PARTS CATALOG

ERD36 Range

ERD36 - TOP FRAME

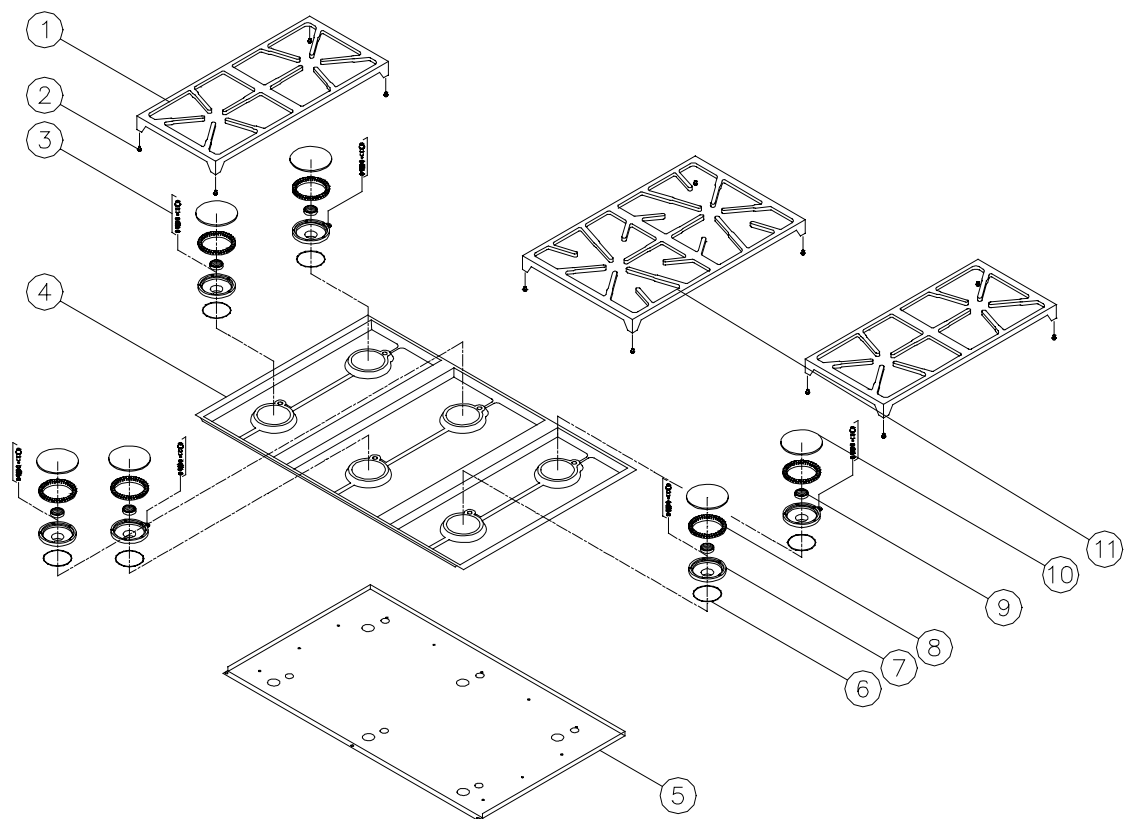
Re: Grates

Grates were changed – the new grates have a smooth porcelain finish rather than the matted black finish of the previous grate

| Model # | Old Part # | New Part # |
|------------------------------------|-------------------|-------------------|
| ERD30/36/48, ESG366/486 | 62881BM | 72434SB |
| ERD36, ESG366 | 62883BM | 72433SB |

Re: Revisions to alleviate an uneven spill tray.

Part # 46130BP (front support angle, spill tray) and part # 83064 (foam countertop seal, qty 32.5) was added to all ERD36 and ERDE36 models.

This bracket corrects sloping grates or uneven spill trays. It is a retro-fittable and can be used on any revision ERD36 or ERDE36.

ERD36 - CONTROL PANEL

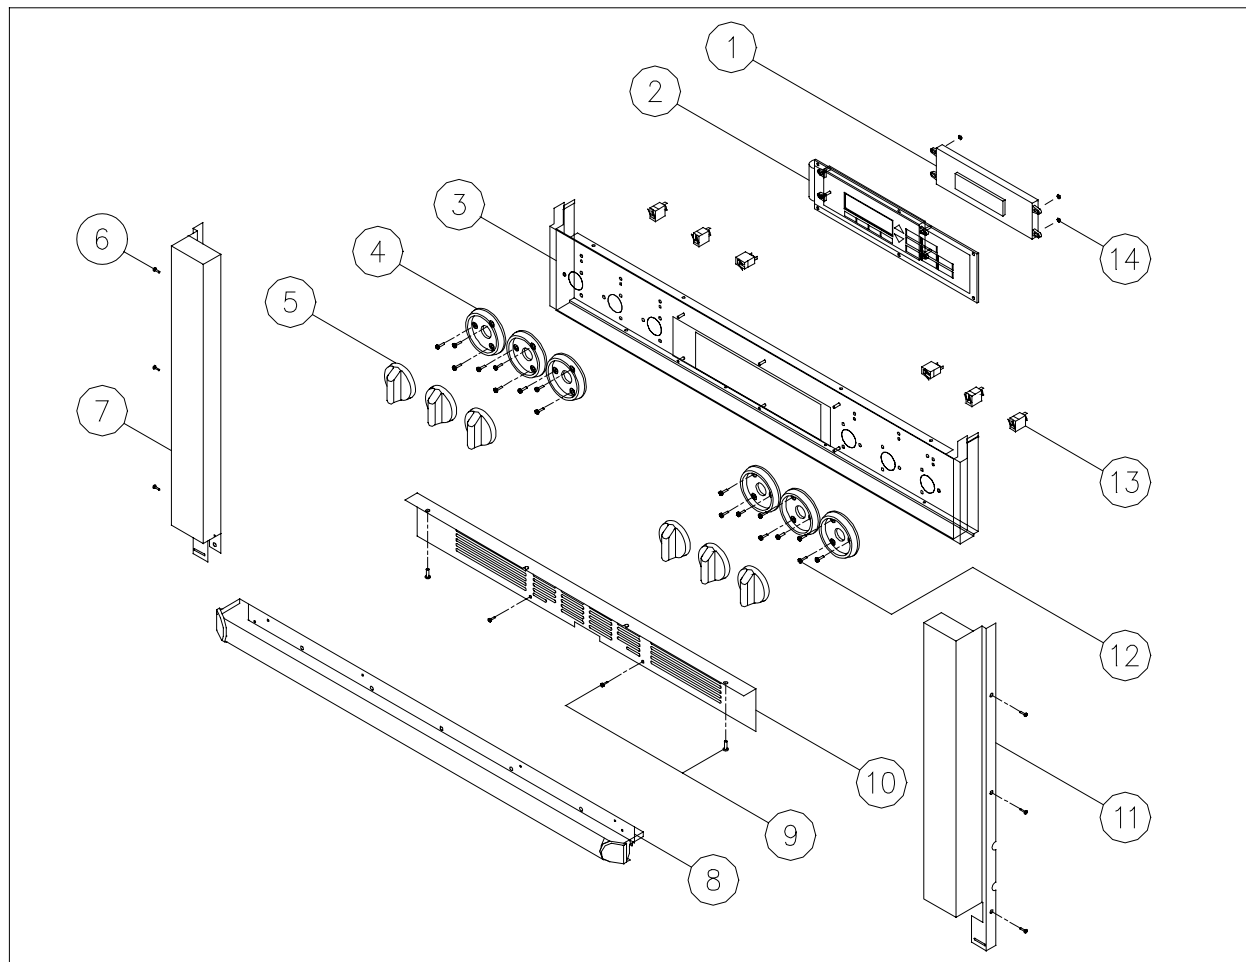
A change has been made to the ERD36 and ERD48. The membrane has been replaced with a new membrane that has no Standard Bake Mode.
P/N 62309 – membrane on the ERD36 was replaced with p/n **72942B**.
ERD48 – Membrane Part Number 62310 - was replaced with p/n **72943B**.
This change was made **February 2, 2004**.

Effective on revision level '**M**' for all **ERD36** ranges and on '**P**' for all ERD48 ranges, the **BAKE** mode has been removed from the membrane. If you are replacing the membrane for either of these two ranges, check the serial number of the unit before ordering the part to be sure that you have the correct part number.

******Membranes will continue to be available with the *bake mode pad* for use with units that currently have bake on the membrane. Membranes should always be swapped out with like membranes.

Re: Bullnose Parts Changes

Condition:
For units *without* grate supports, AFTER the serial break, use part number 66831SBK, SBR, SCH, SCP
For units *with* grate supports, BEFORE the serial break, use part number 86570BK, BR, CH, CP

ERD36- 36" CELL ASSEMBLY

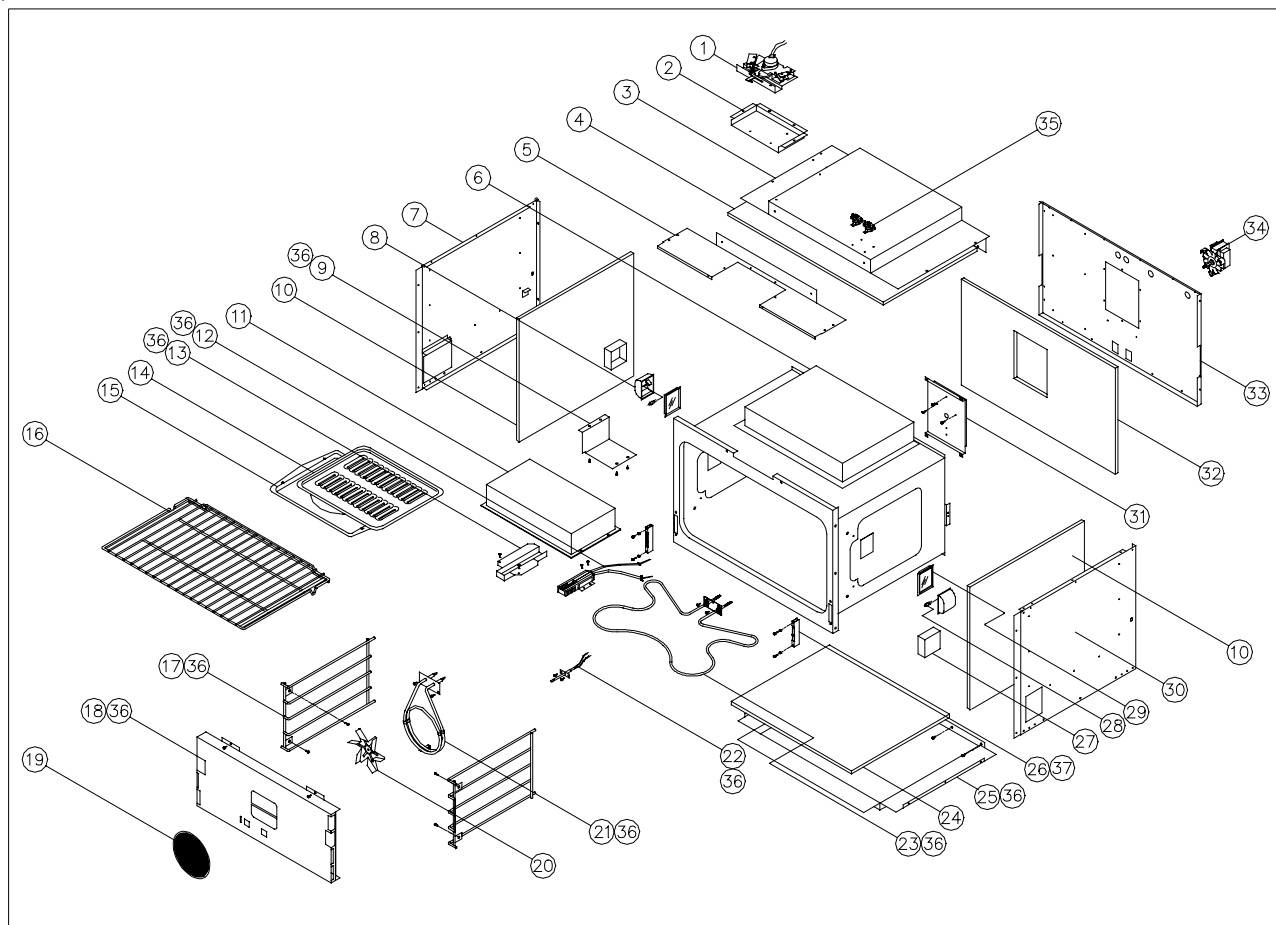
Re: ERD36/48 Rack Supports and Convection Baffles

Revision Level Change:
ERD36 Changed from FF to FG
ERD48 changed from FG to FH

The convection baffle changed to part # 36818BP
The rack support changed to part # 62972

****NOTE:** When changing to the new convection baffle, both the baffle and rack supports must be ordered and installed.
